INSTRUCTIONAL BULLETIN NO. 17-12

Regarding Revised Natural Stream Design Standard Drawings

Effective March 23, 2018 letting (January 10, 2018 Turn-in), the following standard drawings have been revised. Also, Chapter 5 of the Roadway Design Guidelines has been revised to incorporate these changes.

BOULDER TOE
PLAN VIEW

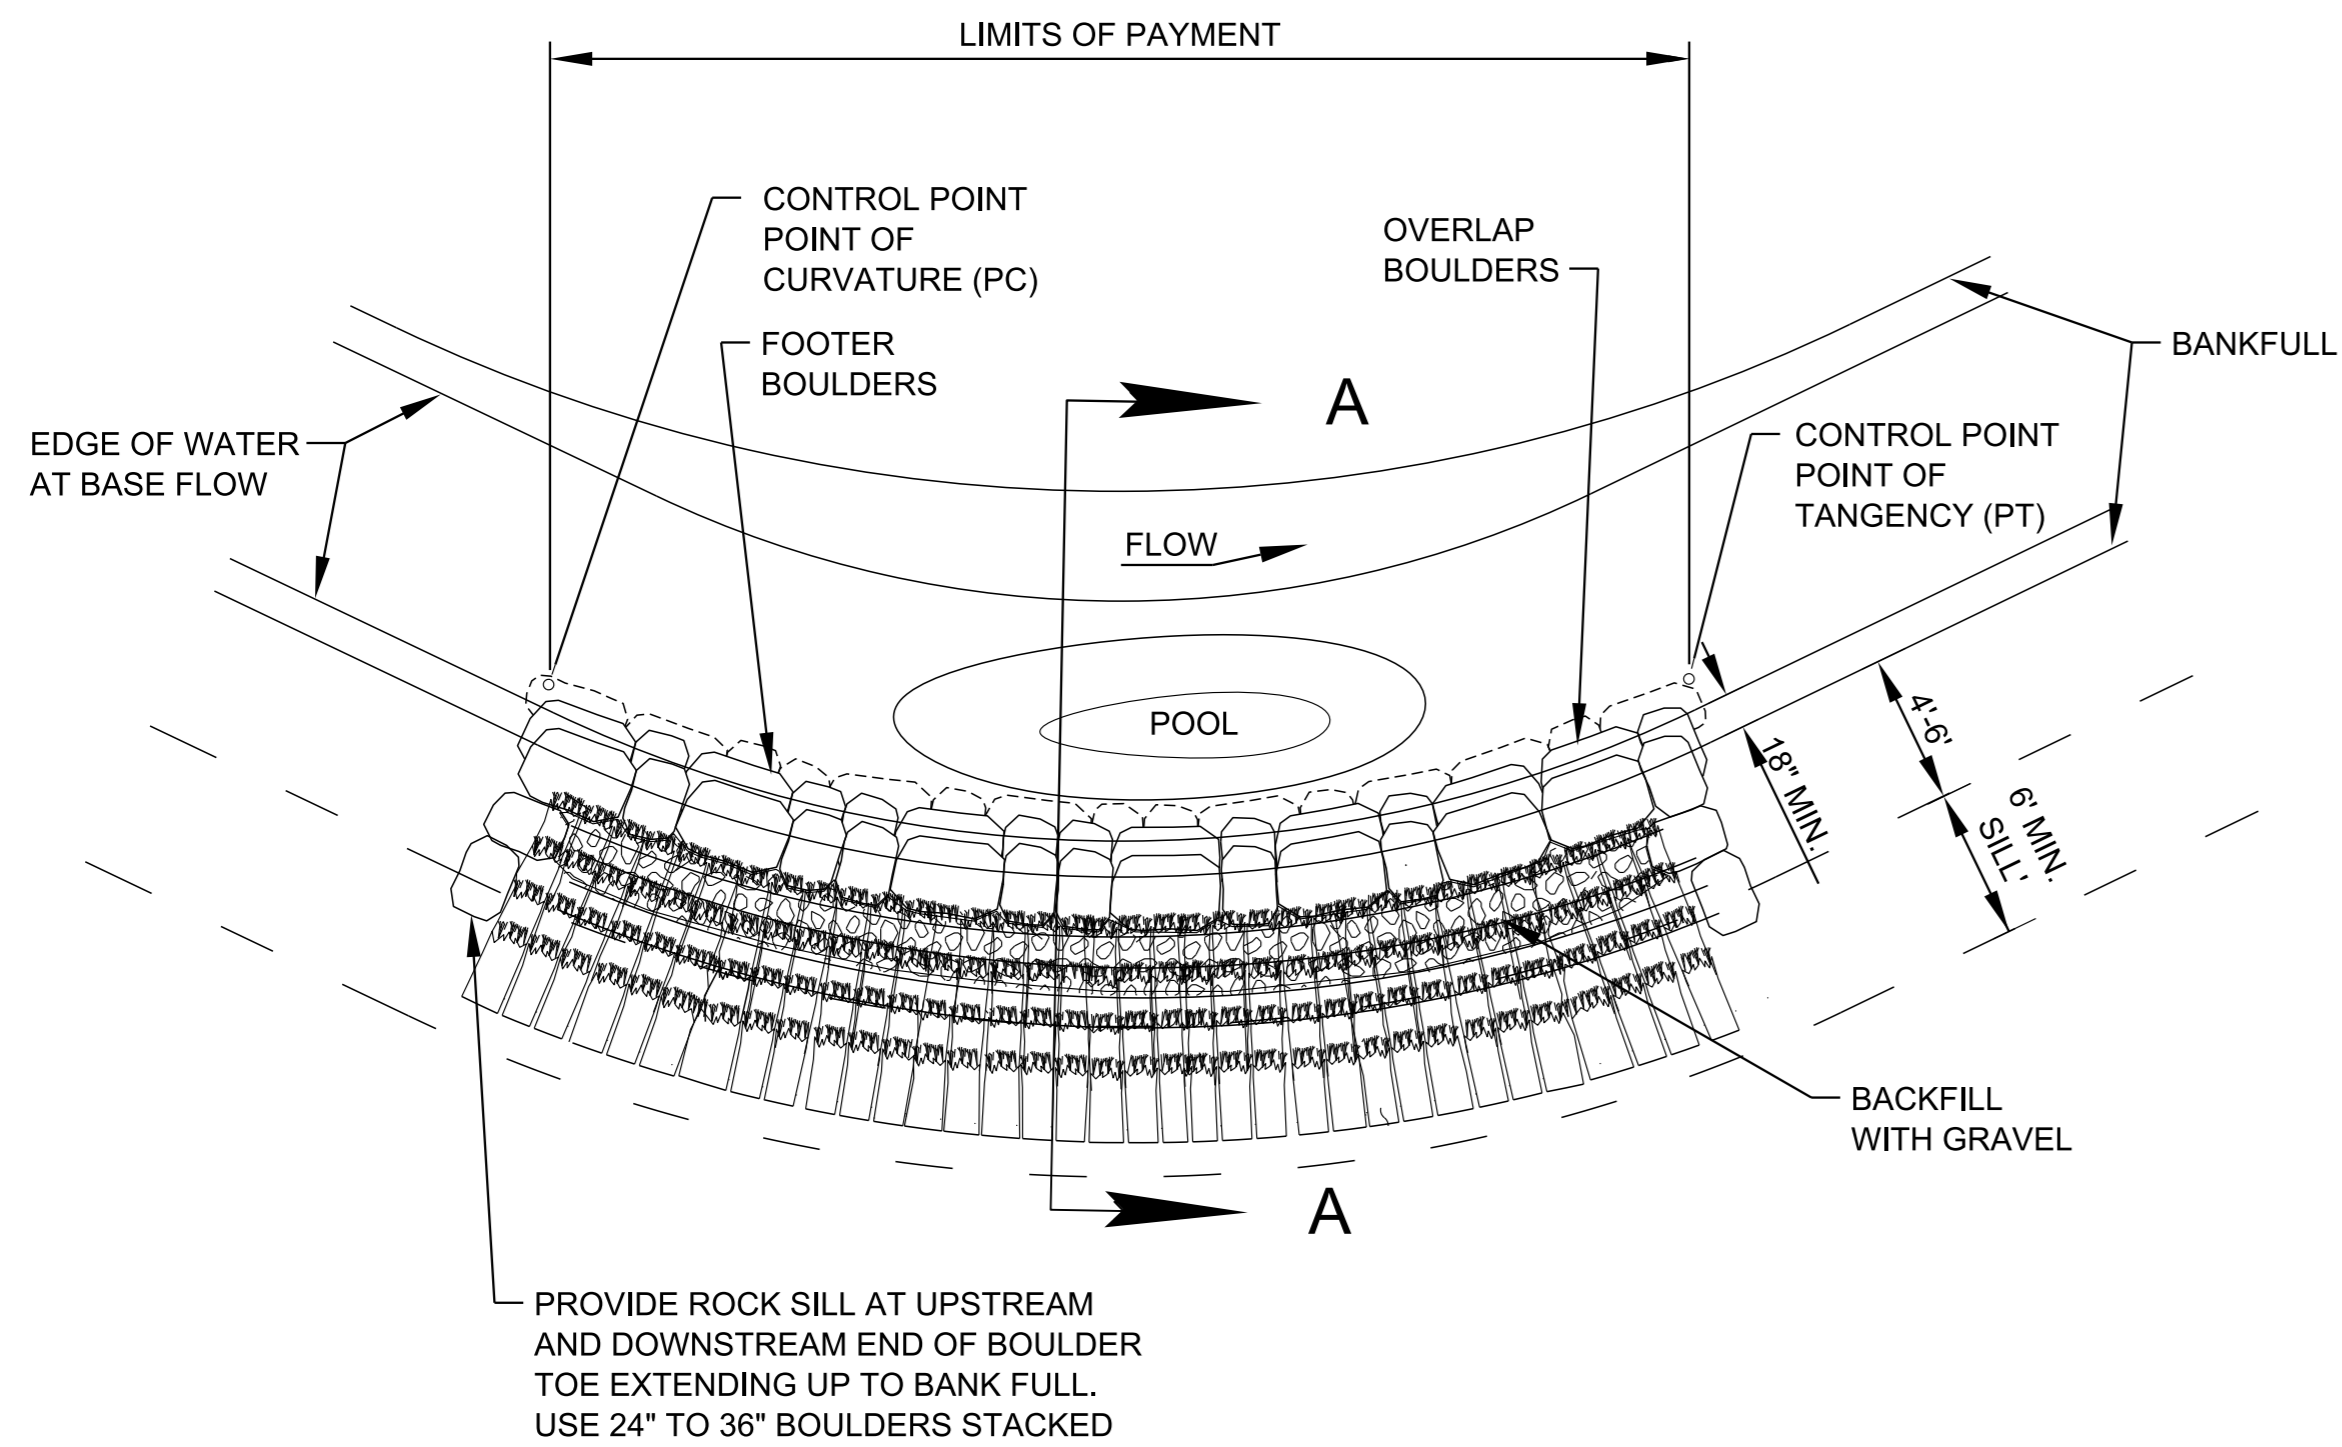
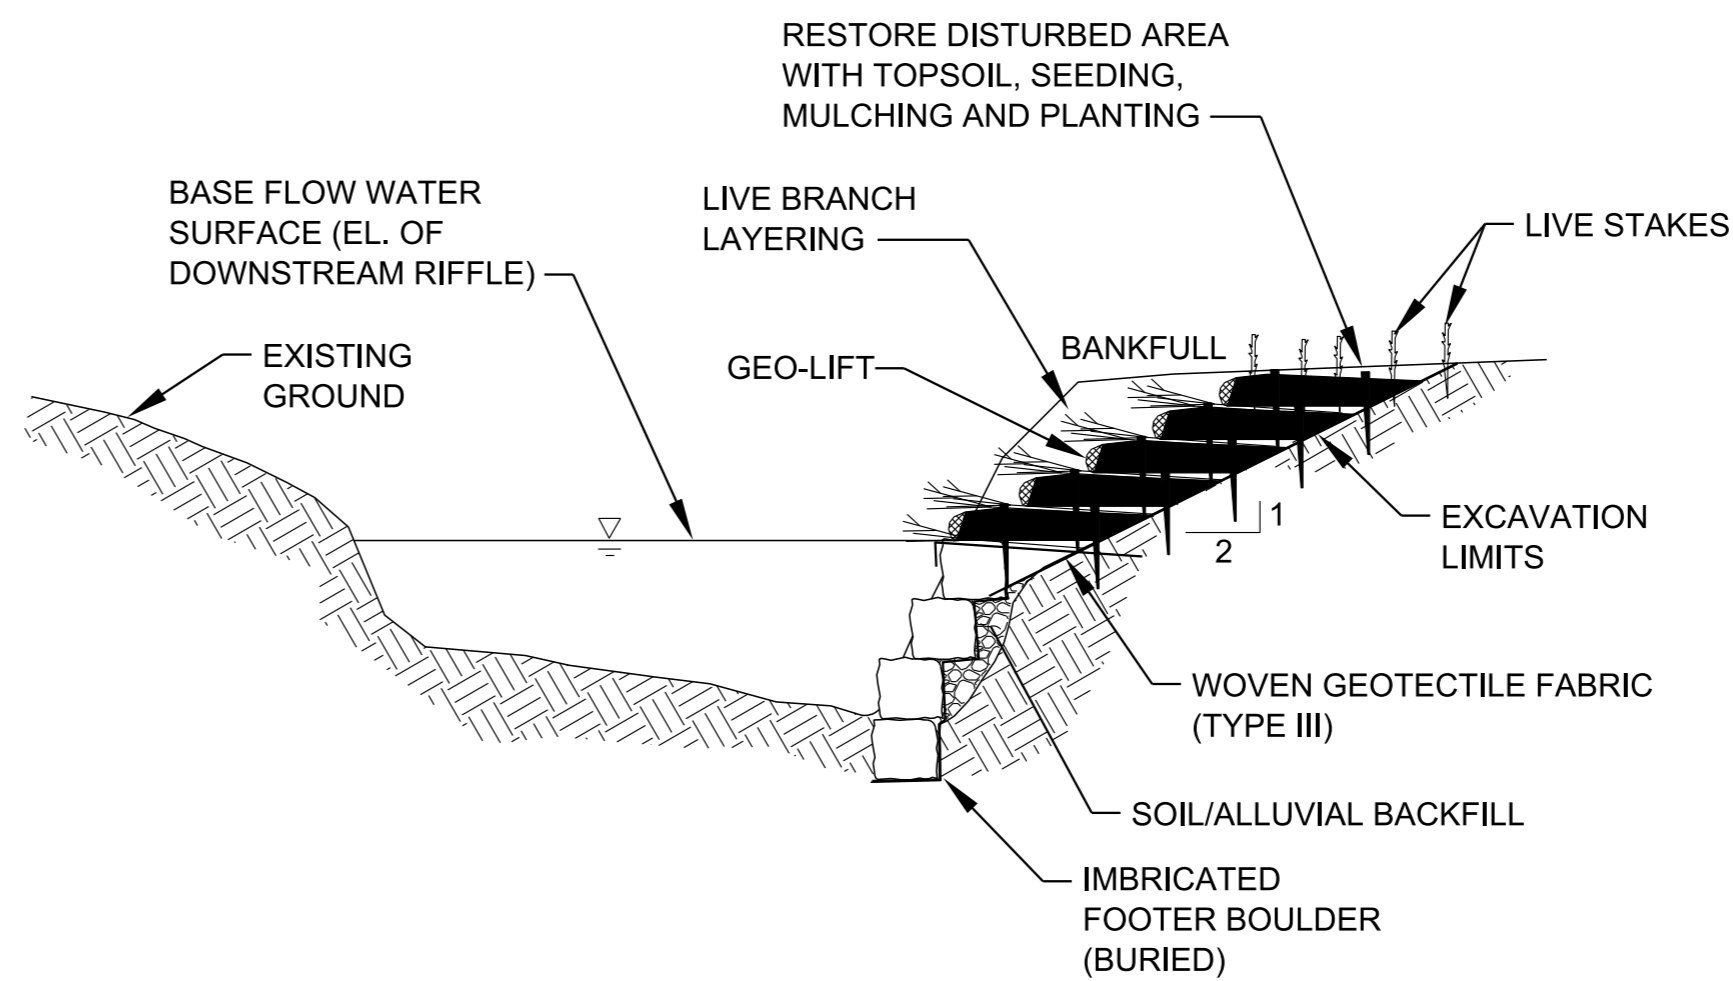
REV. 9-15-17; MODIFIED THE STREAM MITIGATION PLAN LEGEND SYMBOL. ADDED PAY ITEM NUMBERS. ADDED WOOD AND BOULDER TOE WITH GEO-LIFTS NOTES, INCLUDING PAY ITEM NUMBER. MODIFIED THE BOULDER TOE PLAN VIEW. DELETED THE PLAN LEGEND. MODIFIED PAGE NAME, LEGEND AND PLAN VIEW. ADDED NOTES.
